Re: Navy Monitoring Plan, "Homeporting" Project, Coronado, Submitted in Compliance with CD-95-95

**NEARSHORE CONFINED DISPOSAL FACILITY
POST DREDGE MONITORING PLAN**

CVN HOMEPORTING PROJECT

**RESPONSE TO ENVIRONMENTAL HEALTH COALITION COMMENTS ON THE
NEARSHORE CONFINED DISPOSAL FACILITY POST DREDGE MONITORING
PLAN**

Focused RI/RFI Work Plan
Figure 5
Proposed Well Locations
Naval Air Station North Island, San

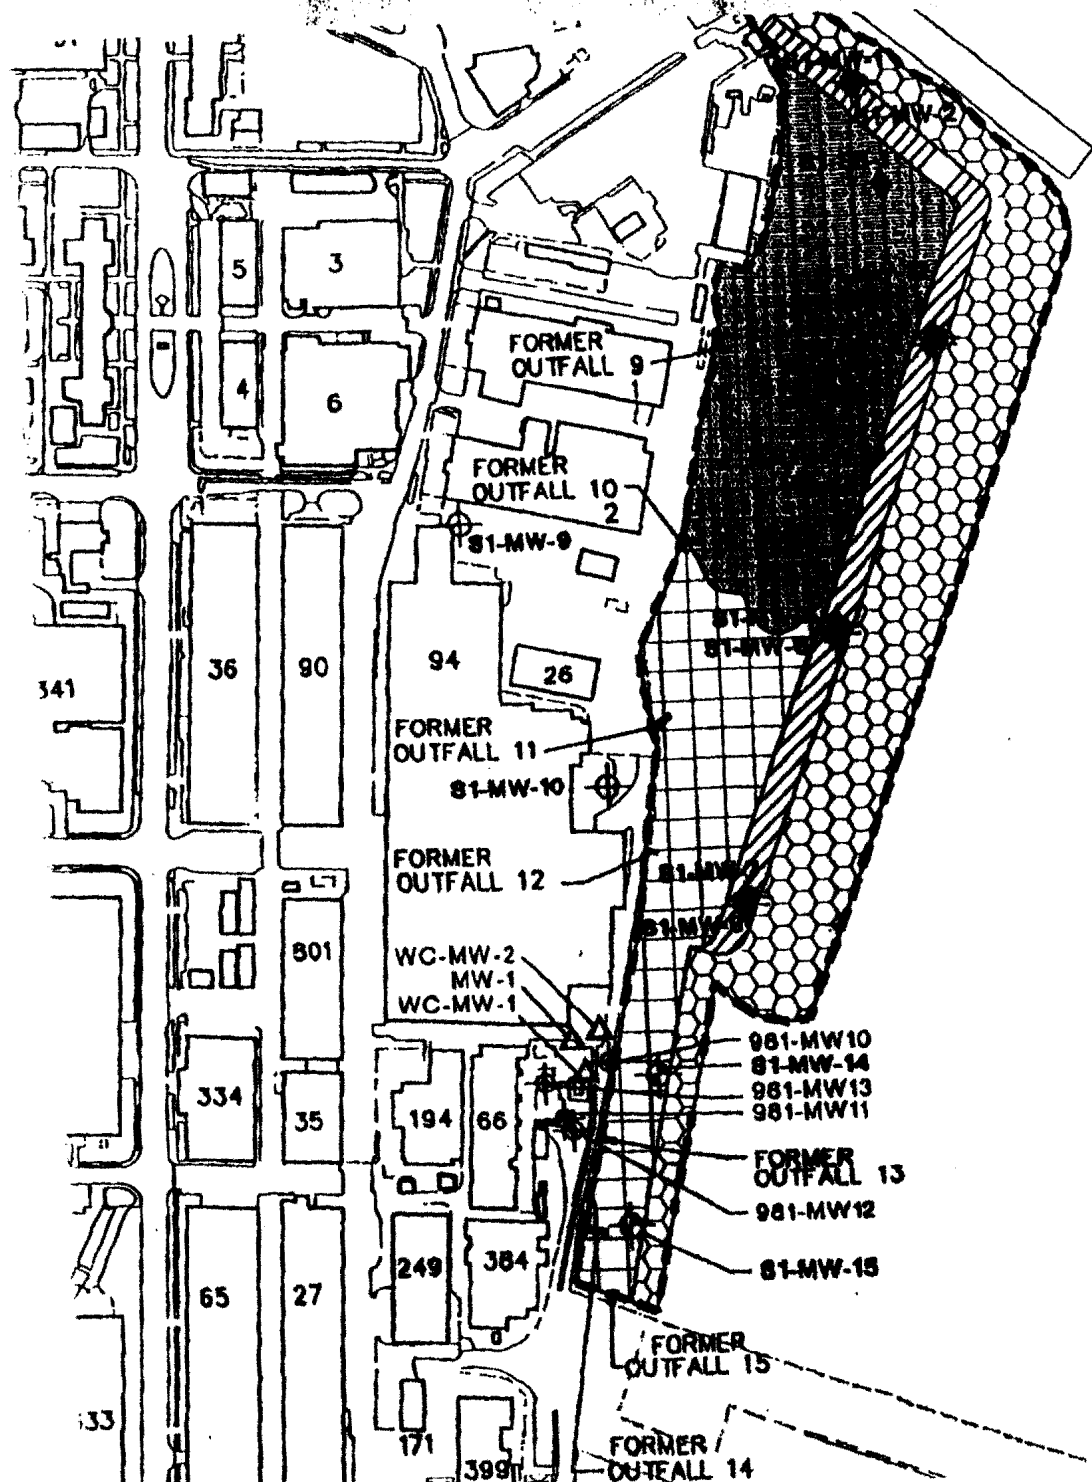
A map depicting the groundwater monitoring well network will be added to the plan.

Ground water sampling will be performed quarterly at fifteen monitoring wells to be installed in locations shown in Figure 5. The details of the well installation, sampling techniques, constituents of concern, and quality control procedures are outlined in the Final Focused Remedial Investigation.
